ADDENDUM NO.: 001

DATE OF ADDENDUM: April 11, 2012

**Roof Replacement Hartford Regional Center  
71 Mountain Road  
Newington, Connecticut 06111  
BI – NN-654**

Addendum 1 Item # 10 SK-1

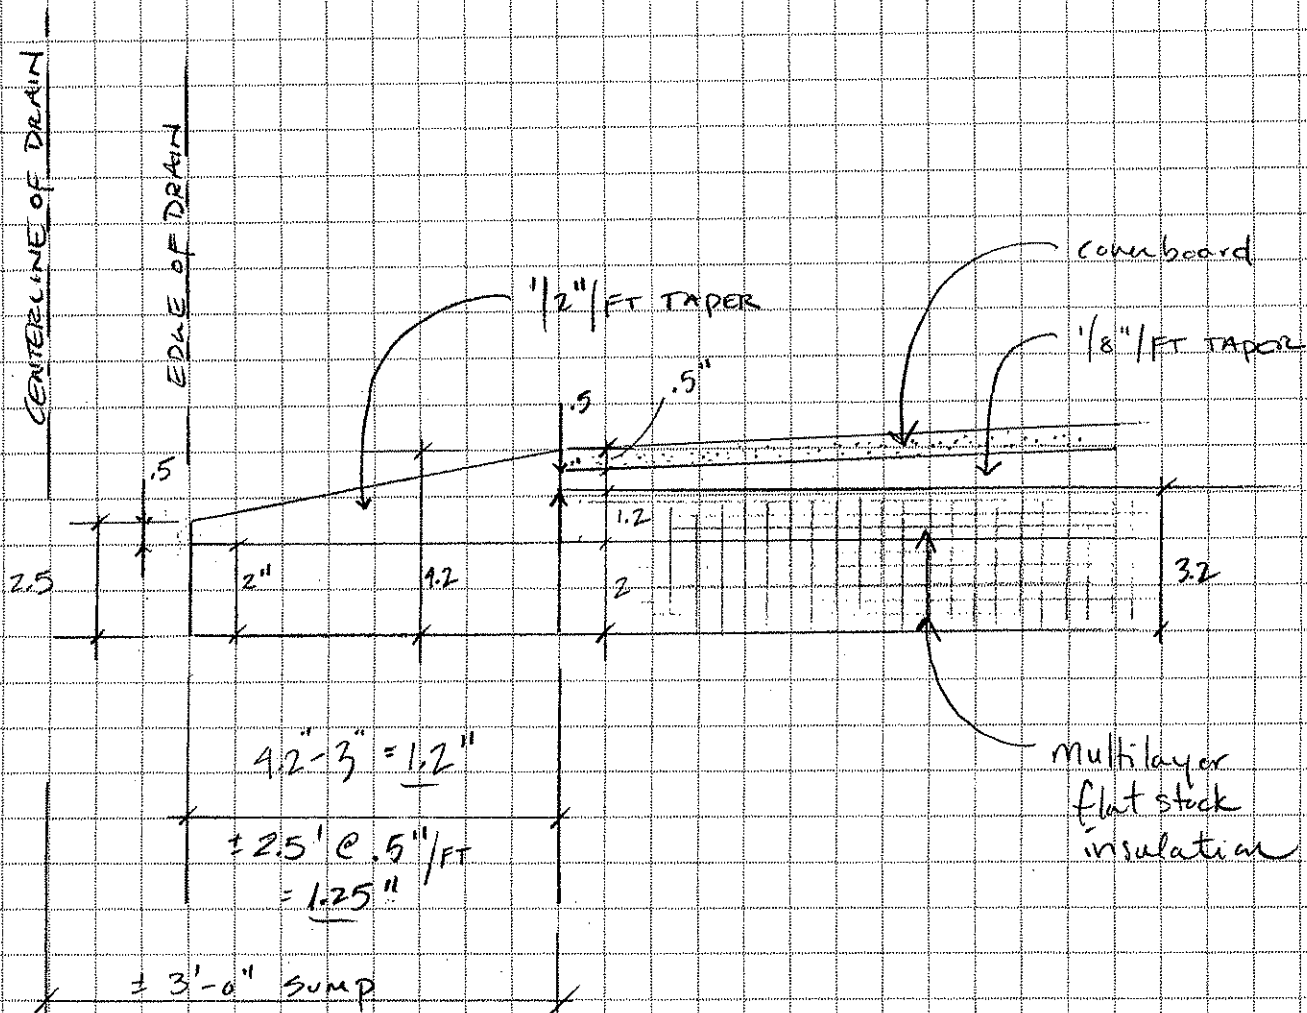
**RFI #003:** "Sheet A1.1; Conceptual tapered plan A1.1 "Key" indicates R-values as an average of R20 while the specifications Section 07 51 00; 2.02 A 1+2 indicate a minimum R19. Which is correct? If a minimum R19 is required the minimum insulation thickness at roof drains will be 3" plus not the 2" as shown on detail 6/A8.4."

**Gale Response:** See attached sketch (SK-1) for clarification. The insulation in the sump should be a minimum of two (2) inch thick. Increase tapered insulation to 1/2" per foot at drain sump locations. Sumps should be approximately six (6) feet square. Flat stock insulation at the edge of the sump should be multi-layered and be a minimum of 3.2 inches thick for a minimum R-value of R-19 continuous across the roof deck. Utilize 1/8" tapered insulation starting from the edge of sump and extending outward onto roof. Average R-value should be above and R-20 when the tapered insulation is considered.
